November 2001

TOPIC: MISSING COUNTERWEIGHTS

AFFECTED: 1000ZKAV23/61 - serial no. 101-150

Figure 1. Install the Counterweights

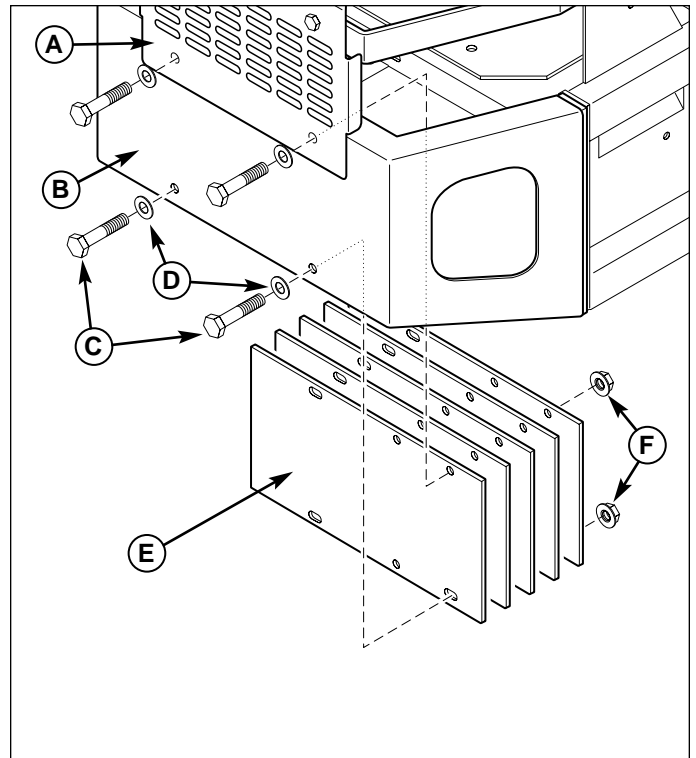
Ferris Industries has determined that the above listed serial number machines were not equipped with the necessary counterweights mounted inside the rear bumper.

To rectify this, install five (5) counterweights (47485) to the rear bumper. This will provide the proper front-to-rear weight ratio for better traction and control on hilly terrain.

1. Remove and discard the (2) 3/8" bolts, washer & nuts that fasten the rear shield (A, Figure 1) to the bumper (B).
2. Install the 3/8-16 x 2-1/4" bolts (C) and 3/8" flat washers (D) through the bumper and rear shield.
3. Install the five counterweights (E) onto the new bolts (C) and secure with the 3/8-16 serrated flange nuts (F).
